Model	VT2100/2130/2150, Ges5310/5315/5320, Rex1240/1241/1242, NSA CP310/315	Volt/Hz	Date of Modification	Serial Number
Modified Article	Parts Catalog			
Reason for Modification	Parts catalog correction

1. Description correction

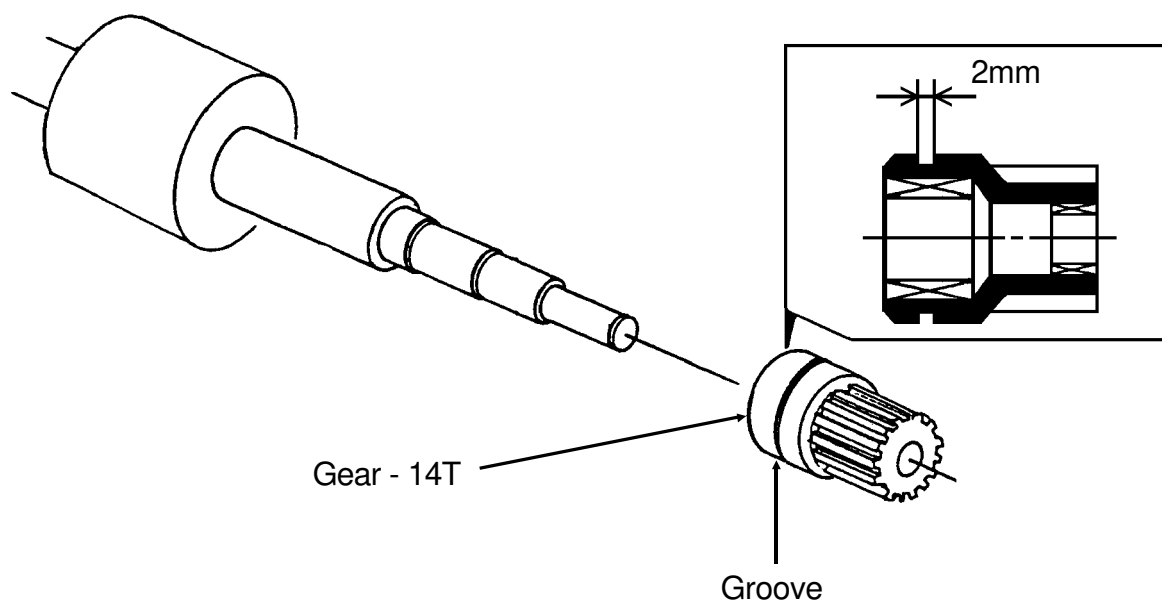
It was reported that on some machines in the field, the image position varies. Although this is a very rare case, at worst this happened after making about 200,000 prints. On the problem machine, the one-way clutch inside the 2nd feed roller gear slips just when the 2nd feed rollers start feeding a sheet. (The paper feed start timing is delayed.) This makes the image position vary, i.e. move up or down in paper feed direction. After investigation, it was found that the grease inside the one-way clutch changes in quality and damage the inside surface of the clutch. The new 2nd feed roller gear contains a new type of grease that does not change in quality unlike the old one. To distinguish the new gear from the old one, a groove is made on the new gear.

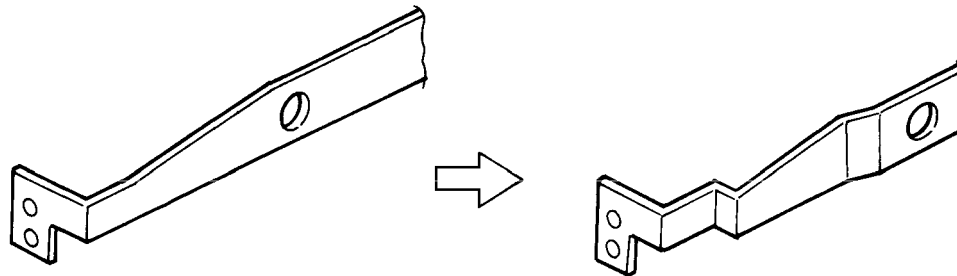
When the paper table is lowered, the feed roller arm contacts the side pad lever if the paper feed side plates are fully opened. To prevent this, the shape of the feed roller arm has been changed as shown in the illustration below.

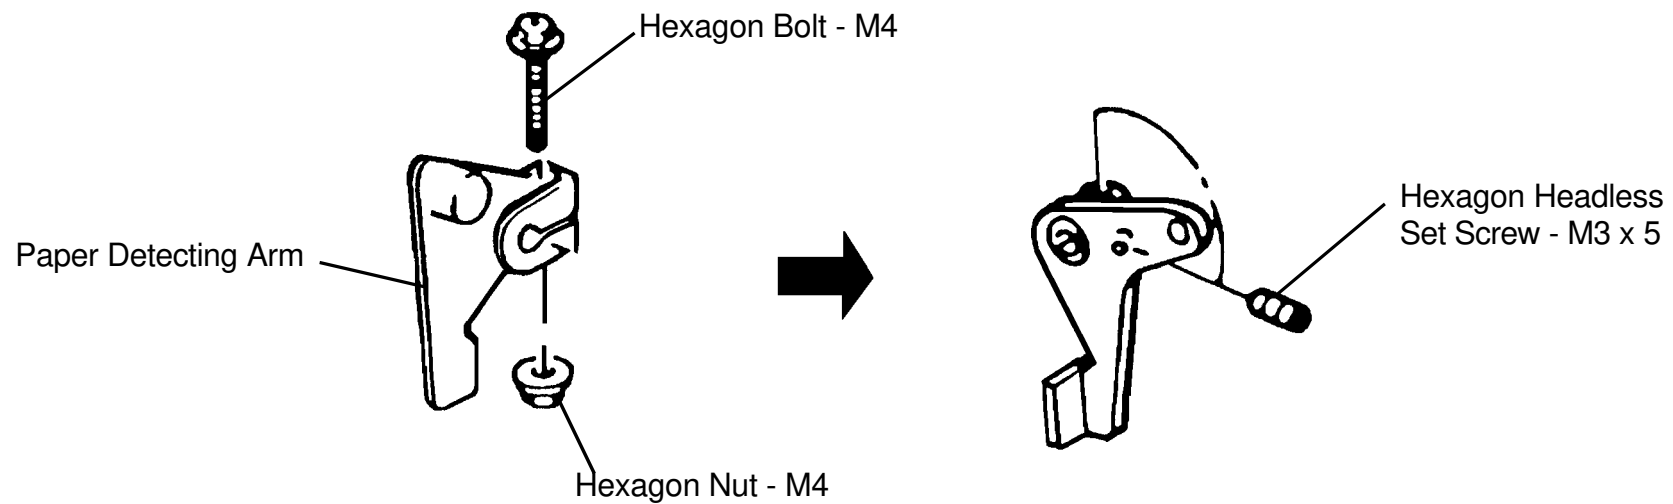
To improve strength and durability, the paper detecting arm has been changed to the type used on the NA2 (C210).

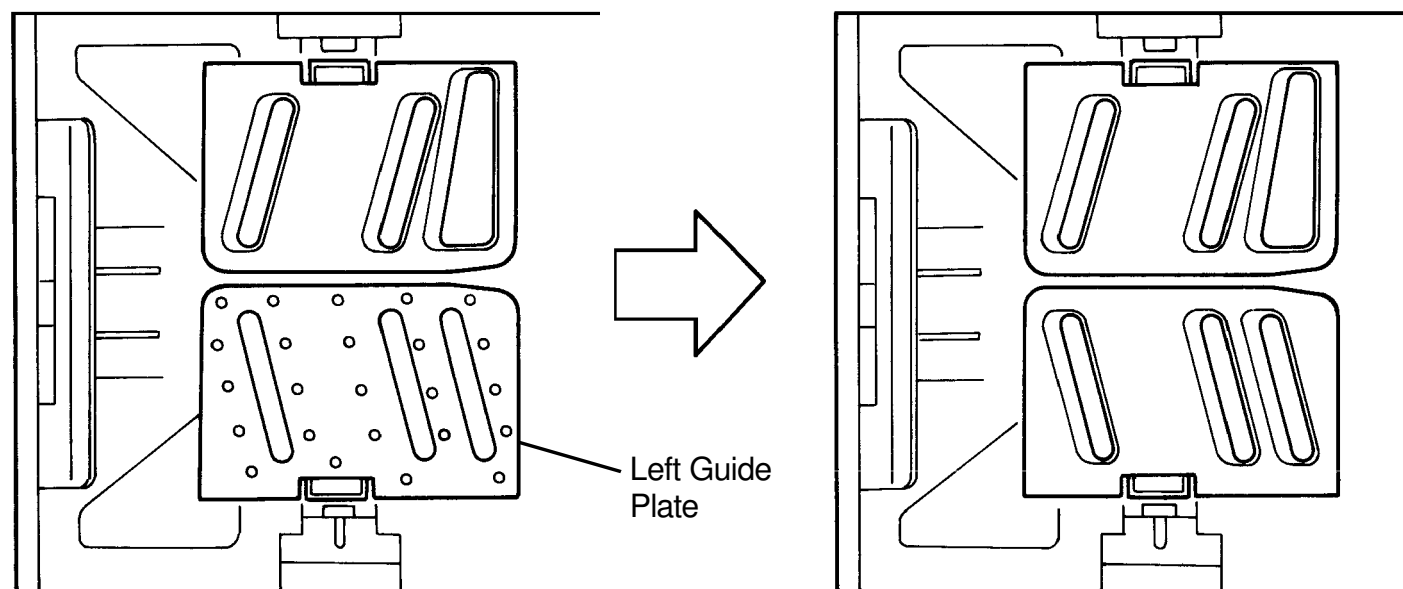
The right guide plate of the priport VT2000 series was changed from that of the priport SS series in order to allow for the installation of the tape dispenser unit. As a result, the appearance of the right guide plate was different from the old one. This was visible especially when the right and left guide plates were closed. (See figure)

Now the left guide plate has been changed to match its appearance with that of the right guide plate. The difference between the new and old one is only in the appearance of the backside (Interchangeability is O/O).

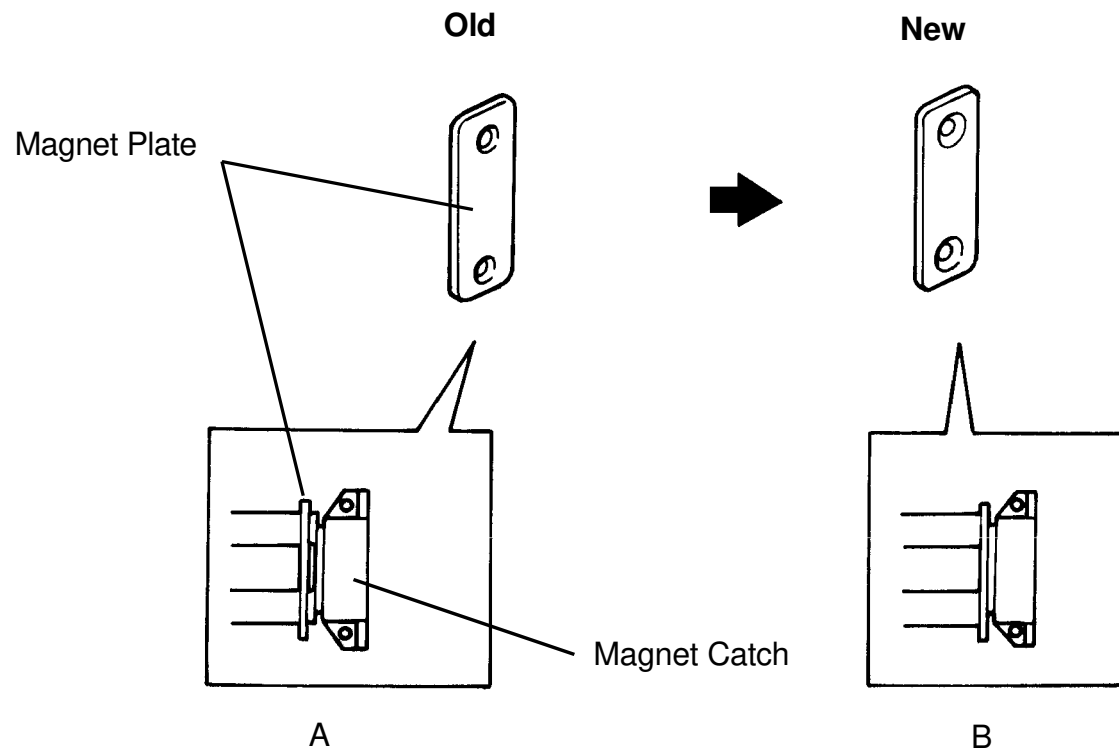
In VT series, the flat head screws fixing the magnet plate project out of the holes of the magnet plate because the heads of the screws are a little bigger than the holes. This weakens the attraction between the magnet catch and the magnet plate (illustration A).

To increase the attraction, the holes of the magnet plate have been made bigger so that the magnet sticks the magnet plate tightly (illustration B).

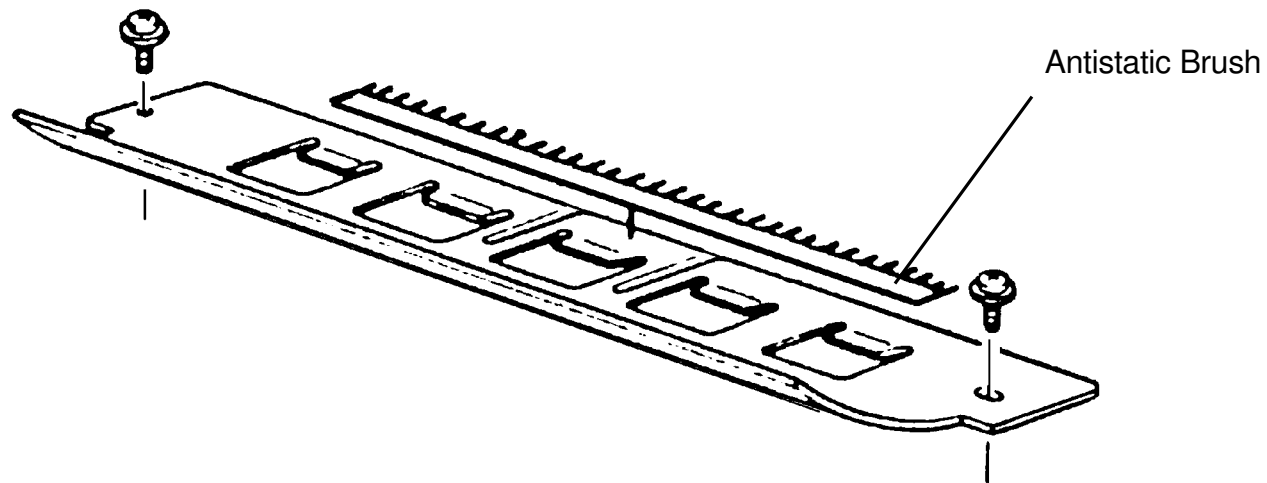
To prevent paper jamming under low humidity conditions caused by static electricity on the paper, an antistatic brush is added on the upper second feed roller guide plate. Refer to RTB No. 3 for details.

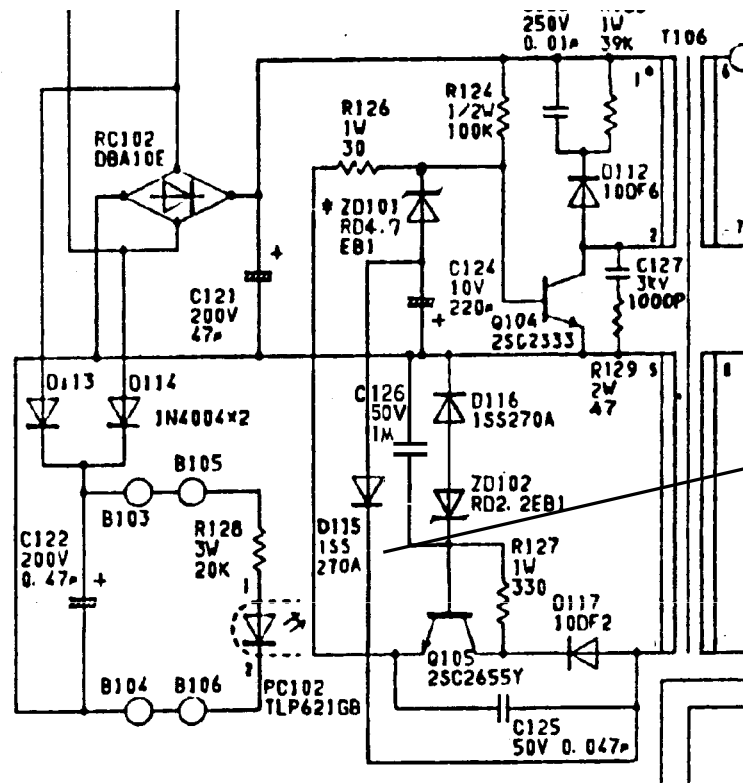
To ensure that the power supply circuit responds quickly (Refer to the MB No. 7), a ferrite core is added to the anode of the diode D115.

Part number of the power supply unit has not been changed but suffix has been changed to B.

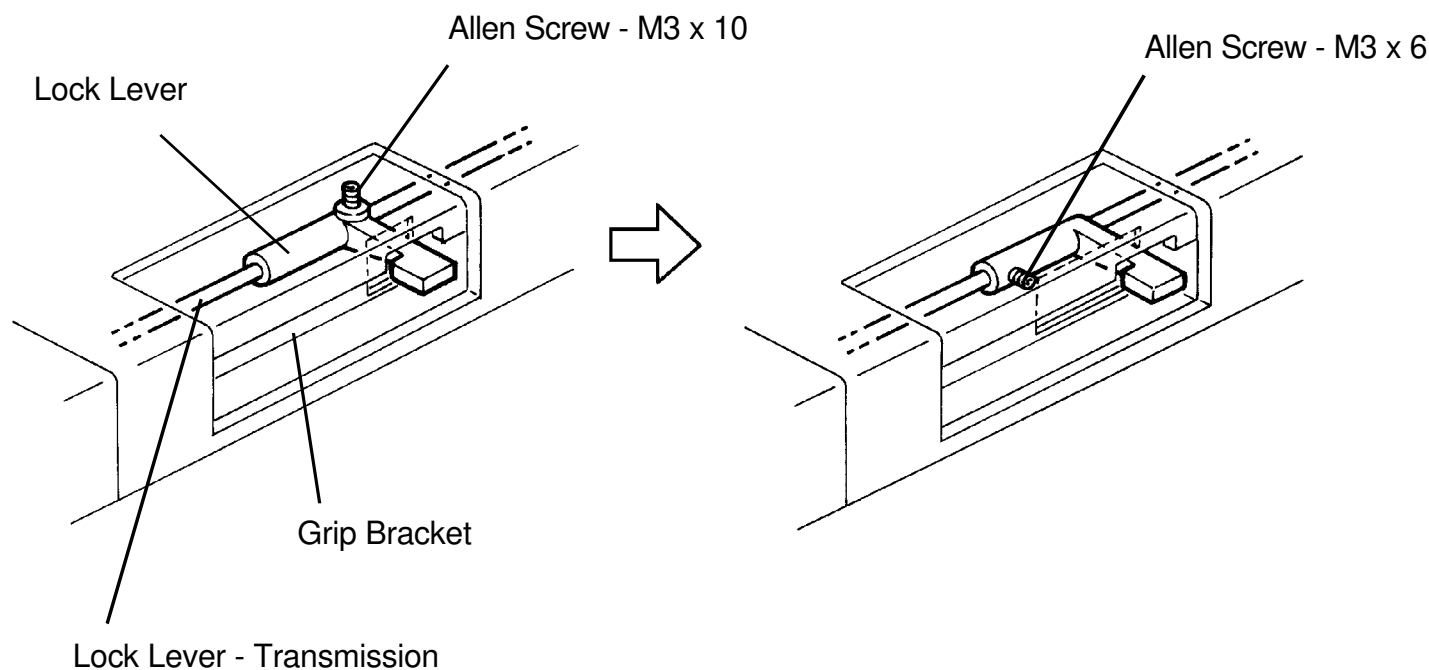
In the present machines, it is difficult to tighten the screw fixing the lock lever to the shaft. It is necessary to remove the scanner unit to access the screw.

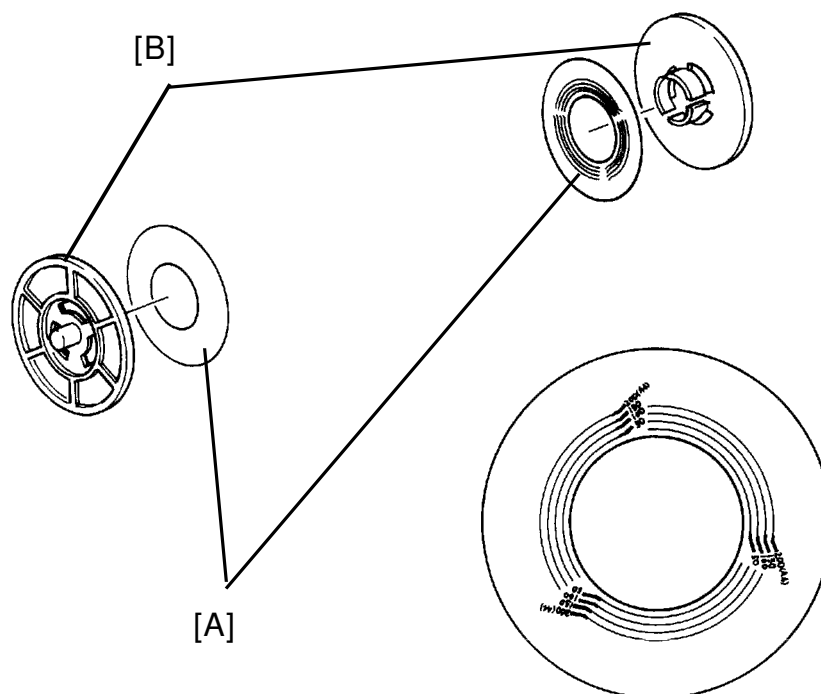
A master flange decal [A], which shows how much master is left on the roll, has been added to the master roll flange [B]. The following table shows the machine type, flange, and decal combination.

Illustration 1

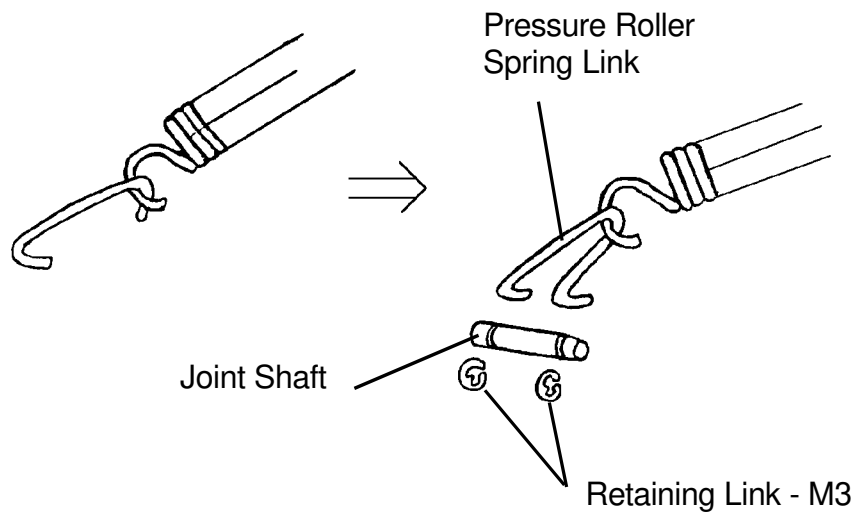
To increase the reliability, the pressure spring link is modified as shown in the illustration 1. Due to this modification, the adjustment value of the bolt clearance [A] has been changed as shown in the illustration 2.

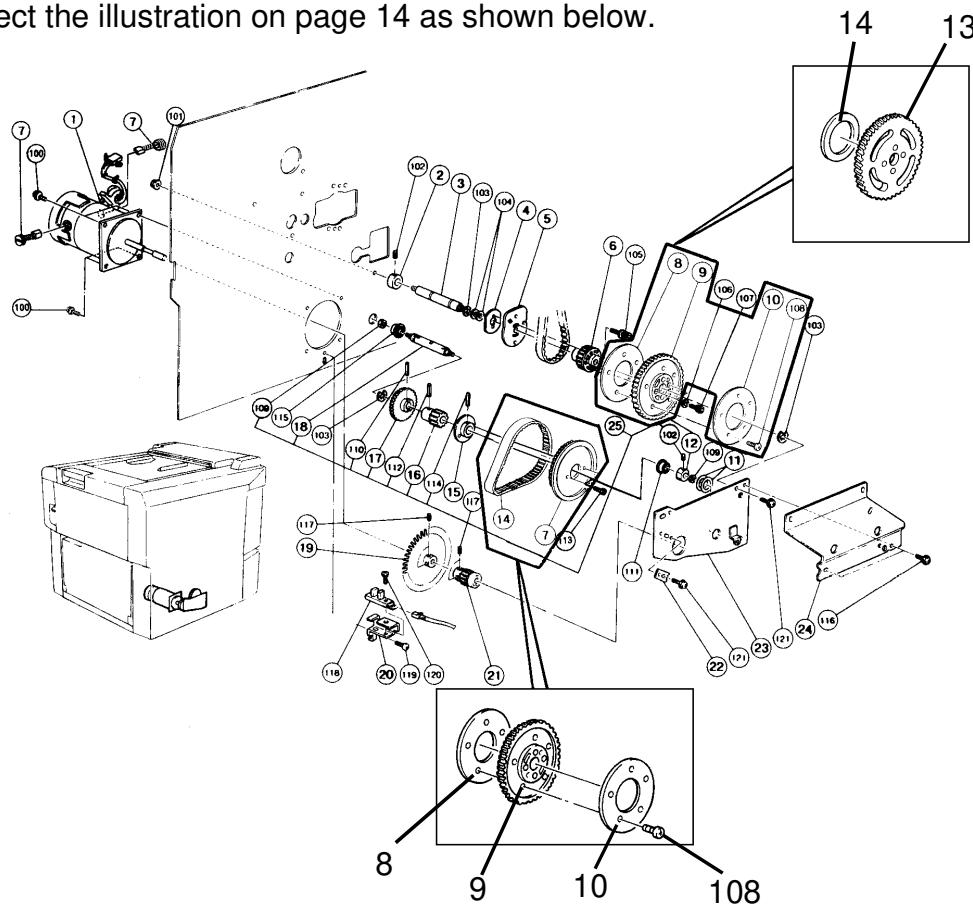
Please correct the illustration on page 14 as shown below.

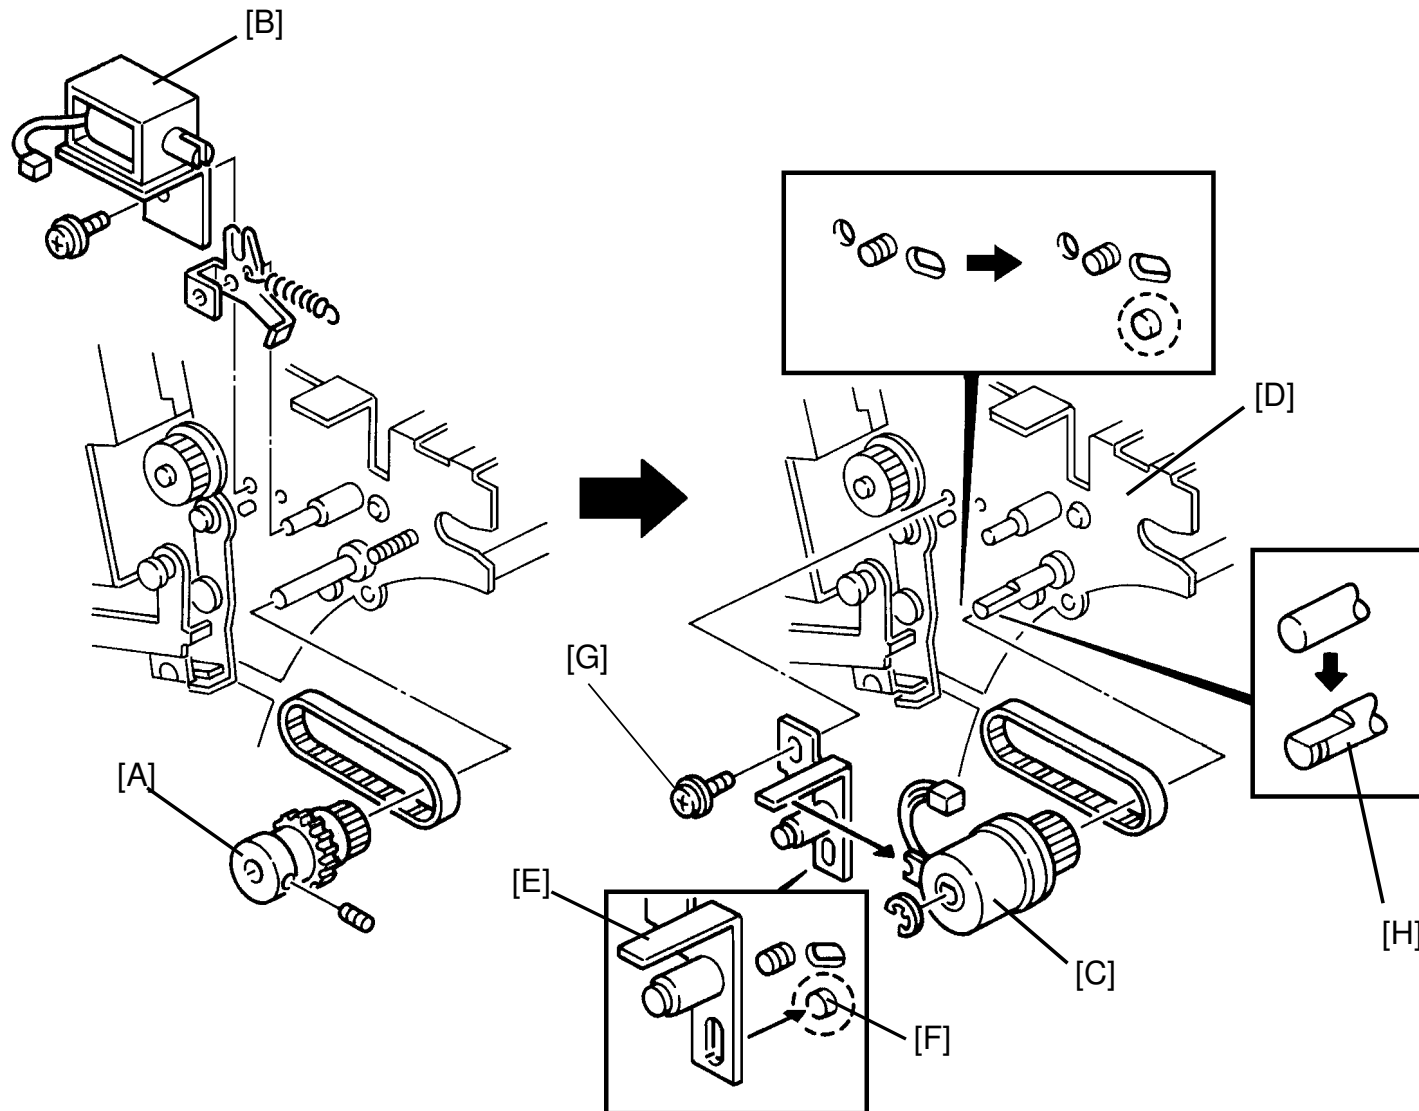
It has been found that a horizontal thin white line appears 64 mm from the leading edge of prints. The line may be visible when the image is made using the photo mode. This line is caused by a shock wave when the master is clamped by the drum master clamber.

1. To erase this white line, the software has been changed to delay the timing of the master clamping. With the old software, the reverse roller solenoid [A] and the master clamber solenoid were turned off at the same time. (Due to the slow response of the old spring clutch, the reverse roller stops feeding the master after the master was clamped.) The new software enables that the master is clamped when the master is fed 2 mm further after the reverse roller stops feeding the master. This allows to make a small buckle of the master, which absorbs the shock wave, between the platen roller and the reverse roller before the leading edge of the master is clamped.

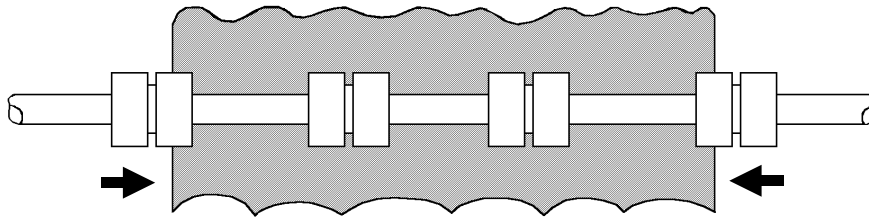
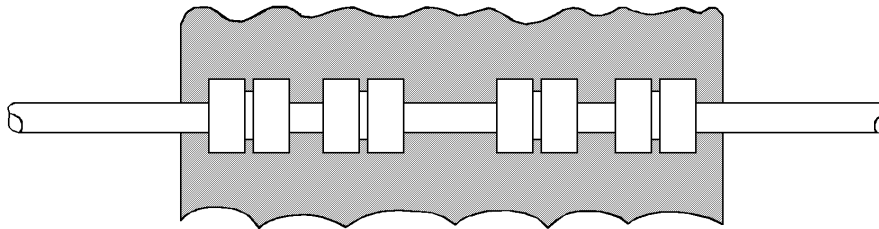
There are 4 sets of master eject rollers and belts. In the A4 or 8 1/2" 14" size master version machines, both sides of the 4 sets do not catch the master edges sufficiently while transporting it. Even with this mechanism, used masters can usually be ejected properly. However, when a master eject jam occurs in this area, the jammed master tends to be creased among the rollers and belts. In the worst case, the master eject belt will slip off when the operator roughly removes the creased and jammed master.

To prevent this, both sides of the 4 sets of the master eject rollers and belts have been moved more inward 20 mm so that they can catch the master more sufficiently (just like the B4 size master version machines). To do this, the following changes have been implemented.

- 1) To move the 2 outside second lower eject rollers inward, the bottom plate of the master eject unit (# C2033527) has been changed. (The guides for the 2 rollers, which are fixed to the bottom plate, have been moved.)
- 2) To move the 2 outside of the first upper and lower eject rollers to inward, the assembled first upper and lower eject rollers (# C2003539 and # C2003542) have been changed.
- 3) To move the 2 outside second upper eject rollers inward, the positions of the grooves for the E-rings that fix the rollers on the shaft (# C2013530) have been moved.
